Certificate of Appropriateness

2107 E. Kenilworth Pl., North Point South Historic District

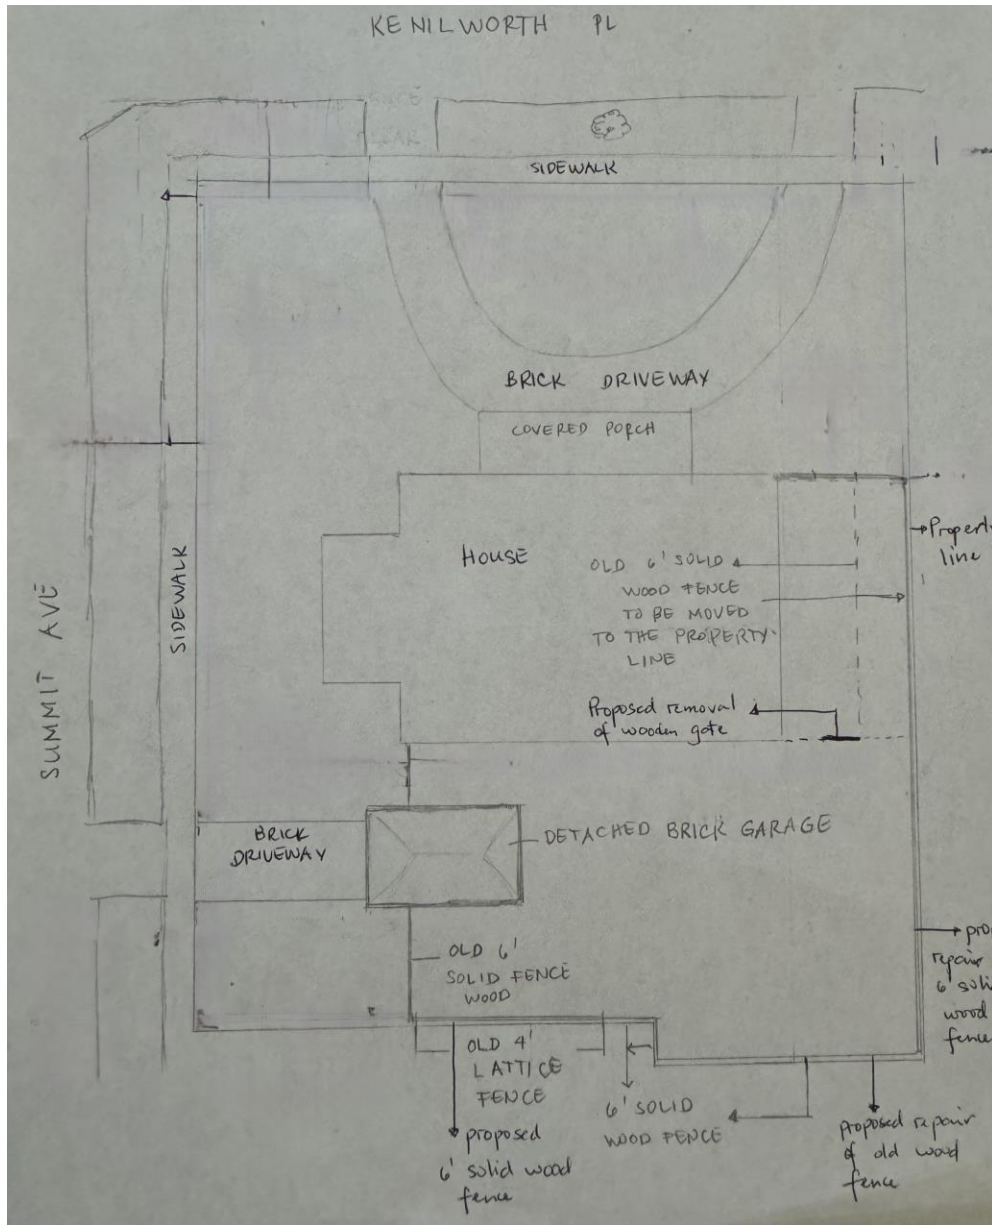
Existing wood fences to be repaired/replaced

Scope of work for the wooden fences. Fence in east side yard must be 4' solid with optional 2' lattice top

Garage to receive new roof, soffit and fascia repairs, new gutters, door repair, and removal of flat plywood on front of doors to expose historic door design.
